SERVICE BULLETIN 42

SUBJECT: INADEQUATE FT NOSE WHEEL PIVOT RANGE

APPLICATION: First production run of Glasair FT landing gear:
(These parts were supplied in kits shipped prior to October 15, 1985).

FIGURE (1)

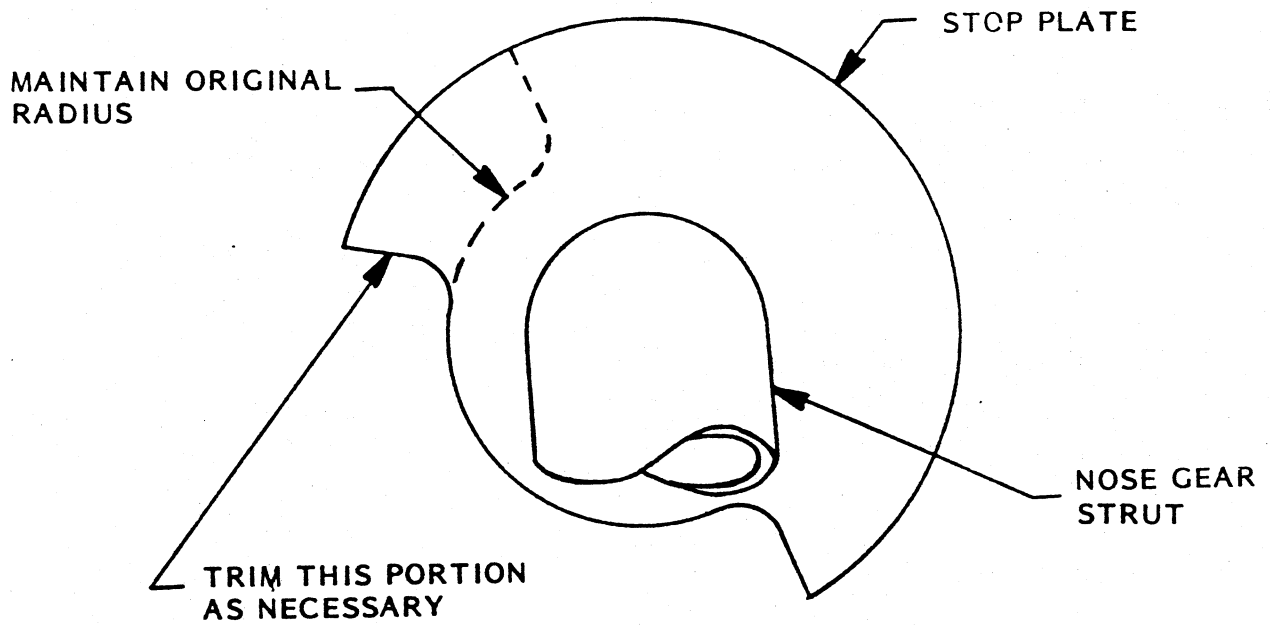
DESCRIPTION: On affected aircraft, the configuration of the nose gear stop plate (welded to the nose gear strut) and the nose gear wear plate (bolted to the stop plate as shown in FIGURE [C-20] on page C-28 of the Glasair FT Instruction Appendix) is such that the nose wheel can pivot almost 90° in one direction but only about 45° in the other direction.

SOLUTION: If after finishing the airplane you find this pivot range limitation to be inconvenient, carefully cut (a good hack saw blade will easily cut the material) and grind away part of the nose gear stop plate/wear plate assembly to allow the landing gear to pivot to the same angle in both directions. Remove the minimum material necessary to achieve the same pivot range in both directions. Continue the existing cut around the plates, maintaining the same radial distance from the strut, as shown in FIGURE (1).

CAUTION: Be careful when cutting and grinding the nose gear strut assembly. The entire nose strut is heat treated, so cut slowly to prevent building up excessive heat that might destroy the temper of the strut.
